CITY OF PLACERVILLE, CALIFORNIA

MADRONE AND GIOVANNI SEWER LIFT STATIONS REHABILITATION PROJECT CITY PROJECT No. 40330

ADDENDUM No. 4
October 3, 2017

GIOVANNI & MADRONE SEWER LIFT STATIONS REHABILITATION
**TYPICAL ELECTRICAL
DETAIL NO.2**

METER/MAIN DISCONNECT (A) (E7)
NOT TO SCALE
DETAIL

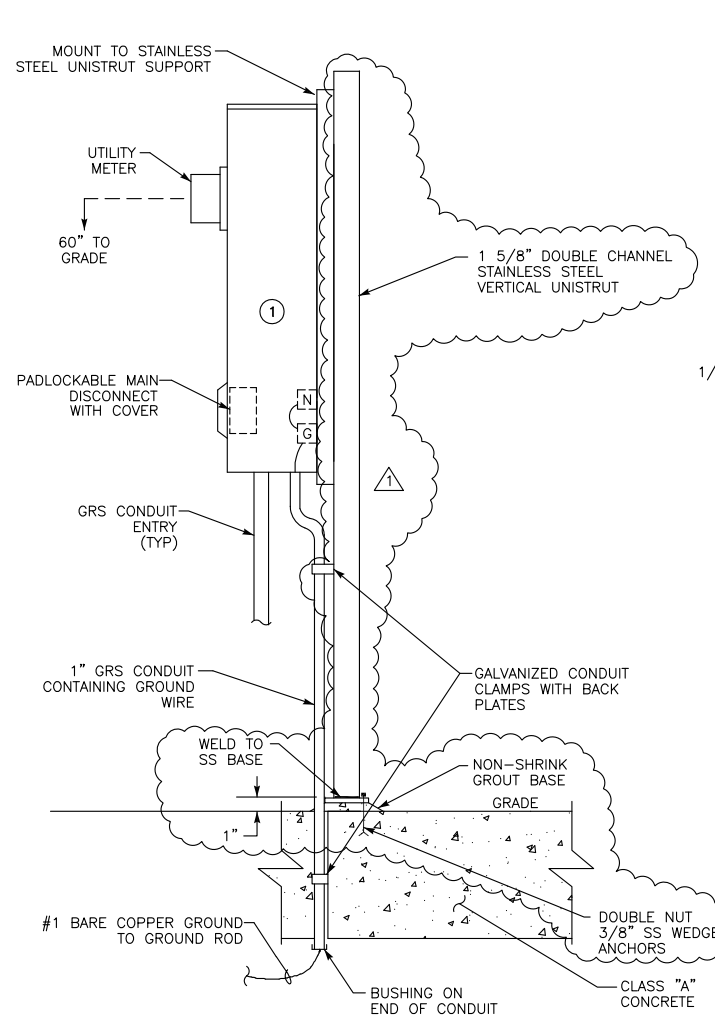
1. Sheet E7 – Typical Electrical Detail No. 2
 - a. Revised meter main installation, Detail “A”.

1. Sheet 8 12 note 7 regarding the new meter main that is being installed directs us to sheet E7 detail A. This detail indicates a meter main being attached to another panel. The meter main at Giovanni Lift Station seems to be stand alone. Please provide a detail for this installation.

5. Sheet E22 note 7 regarding the new meter main that is being installed directs us to sheet E7 detail A. This detail indicates a meter main being attached to another panel. The meter main at Madrone Lift Station seems to be stand alone. Please provide a detail for this installation.
 - a. See attached revised meter main installation detail "A" on Contract Drawing E7.

- a. See attached revised meter main installation detail “A” on Contract Drawing E7.
2. At Giovanni the plans call for EYS fittings where the conduits enter the wet well. The conduits are entering below grade and the EYS fittings need to be accessible. Is it acceptable to install two non-traffic rated Christy boxes outside the wet well to house the EYS fittings?

PUMP CABLE BOX (B) (E7)
NOT TO SCALE
DETAIL

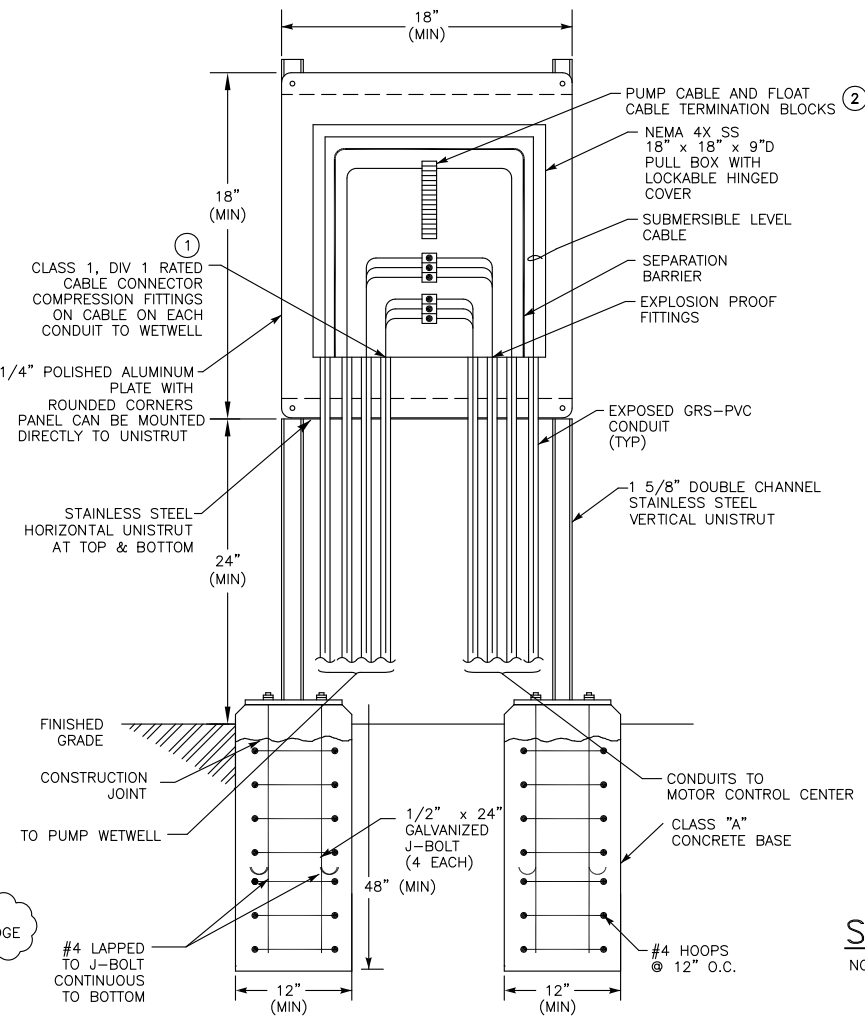
7. The pump cable box shown on sheet E7 detail B is not shown on either site electrical plan is this detail part of the project?
 - a. Pump cable box shall be installed at both Giovanni and Madrone Lift Stations.

- a. Conduits to/from wet well shall be routed through Pump Cable Box shown on Contract Drawing E7, Detail “B”. Pump Cable Box may be installed on the north side of the Pedestal, next to the relocated Area Light. Coordinate with Construction Manager for final location.

REMOVABLE GUARD POST (H) (E6)
NOT TO SCALE
DETAIL

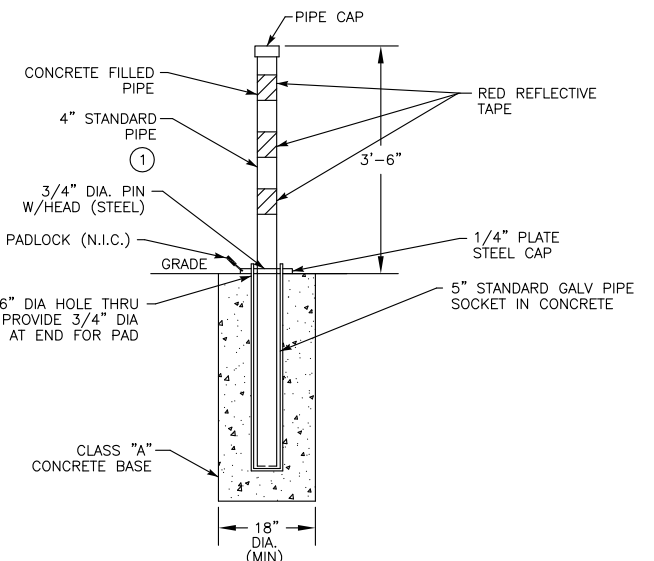
3. Sheet E7 detail H does not provide a depth for the removable bollard footings. Please provide a depth.
 - a. Sheet E7, detail “H”, removable bollard shall have a 3 foot depth.
